Permit Type	Permit Number	Opened Date
Building/Residential/Misc/Deck	B24001417	04/19/2024

SFD/Build a three level composite deck. Ground level 30x20 open deck, second level 24x10 open deck, third level 18x14 open deck with a 12x12 Octagon.

LOCATION DRAWING OF:
**#16024 PHEASANT
 RIDGE COURT**
LOT 9
SECTION 1
WARFIELD'S GRANT
PLAT NO. 9802
HOWARD COUNTY, MARYLAND

Permit# B240001417

DETAIL 1"=50'

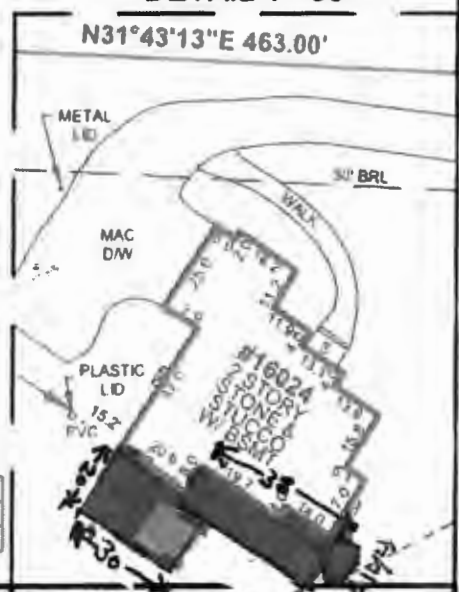
- As mentioned in previous emails, the sewage easement was moved to the upper left-hand corner of the lot. Please delete the platted easement shown on this plan. The office will not approve a deck edge inside an easement
- Once the site plan has been revised, please submit it along with a description of the change to the deck dimension from 30 x 20.6' to 20' x 20.6'. You will also need to update the construction drawing. Once I see the revisions in the system, I will approve the building permit.

- The platted sewage easement has been removed from the site plan as instructed.
- The site plan has been revised to show the scope of the deck to be 30x20.6. The construction drawings do not need to be revised as they are consistent with the revised site plan shown to scale 1:50.

DETAIL 1"=50'

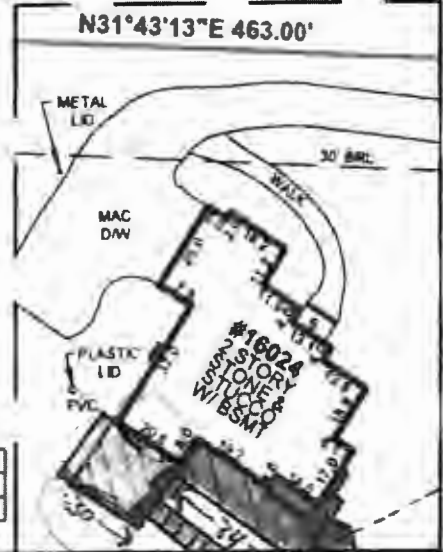
The site plan provided with the building permit (B24000147) application for 16024 Pheasant Ridge Court shows the sewage disposal area (SDA) in the wrong location. In June of 2000, during the installation of the septic tank, ground water was encountered. At that time, additional testing was done, and seasonally high water tables were encountered within the area. This led the inspector to move the SDA to the corner of the lot (see attachment labeled "sda" for location). Also attached, is a copy of the as-built drawing showing the location of the well and septic system components.

Please revise the site plan to **1:50 scale** and show the well, septic system components, and SDA locations meeting the required setback distances. Please see attachment for a list of required well and septic system setbacks. Once the plan has been revised, please forward a copy to me before uploading the revision to the permit system.

DETAIL 1"=50'

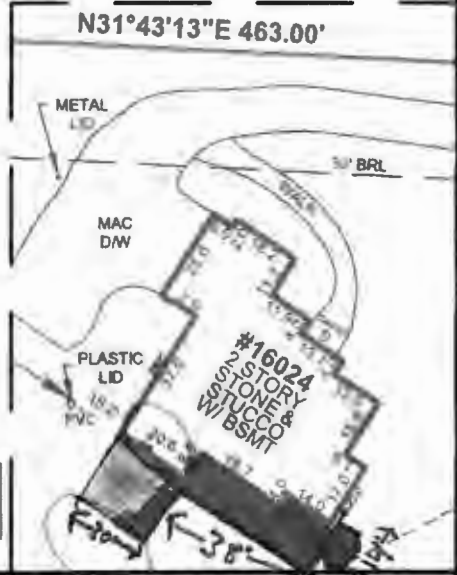
The drawing on the right under Detail 1"=50' shows a house width of 20.6 feet and a proposed deck width of 30'. Shouldn't the deck width be 20.6 feet? Also, as mentioned in previous emails, the sewage easement was moved to the upper left hand corner of the lot. Please delete the platted easement shown on this plan. The office will not approve a deck edge inside an easement.

Once the site plan has been revised, please submit it along with a description of the change to the deck dimension from 30 x 20.6' to 20' x 20.6'. You will also need to update the construction drawing. Once I see the revisions in the system, I will approve the building permit.

See the attached revised site plan.

DETAIL 1"=50'

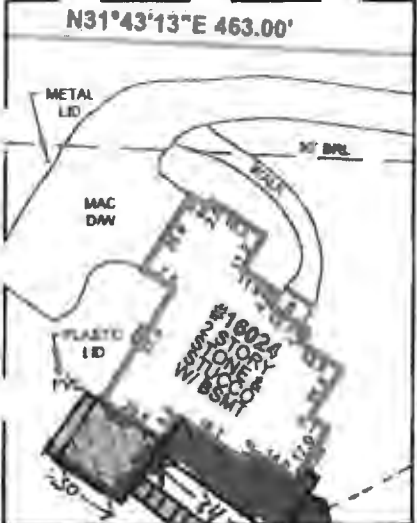
I am not sure if you saw my email response to Mr. Morales on Tuesday. Please see correspondence highlighted in blue. I am looping my supervisor in on this discussion. The original site plan plus the two site plans submitted today were all 1:100 scale and showed the SDA in the wrong location. As mentioned, SDA was moved to the corner of the lot for reasons outlined in my email. In addition, 1:100 scale is too small for me to confirm setback distances. I need a more zoomed in site plan that shows the lot, house site, proposed decks, the well and septic system components. A site plan with a 1:50 scale should be fine. Perhaps you can request a more zoomed in version from the original surveyor. Please let me know if you have any questions.

We were not able to mark the site plan that small ourselves.

The surveyor made the revisions to the attached site plan.
